TSB - FW01

CLUTCH PLATE REPLACEMENT (Upgraded discs)

CHECK HUB CLEARANCE

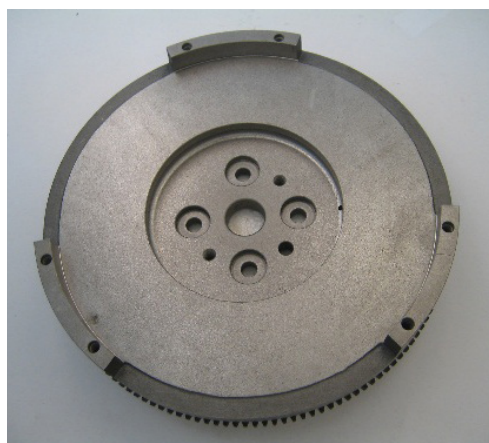
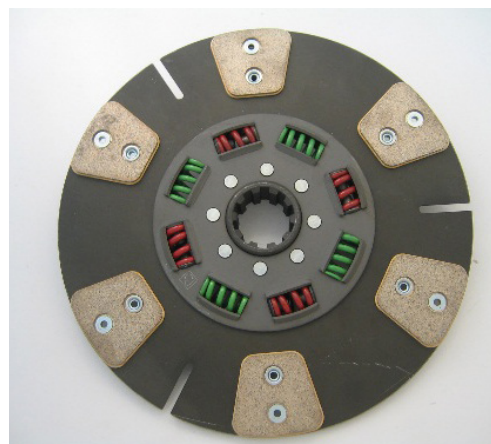
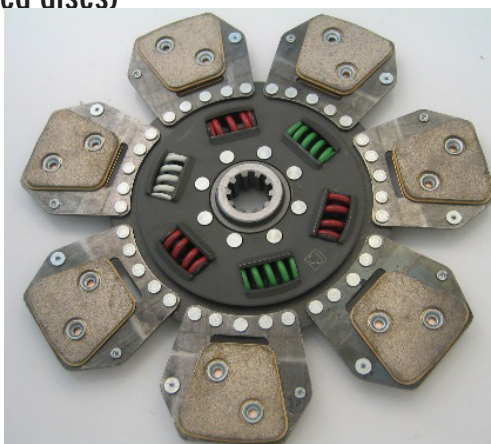
Some manufacturer's discs are rationalized or upgraded for various reasons.

This often incorporates a larger hub design and may therefore require the inner flywheel rebate to be machined to a larger diameter to allow correct hub clearance of the plate.

The diameter should be approximately 2mm larger than the outer segment rivet or the outer hub spring cage as shown above.

Failure to check the above may result in release problems, clutch shudder and premature clutch disc failure.
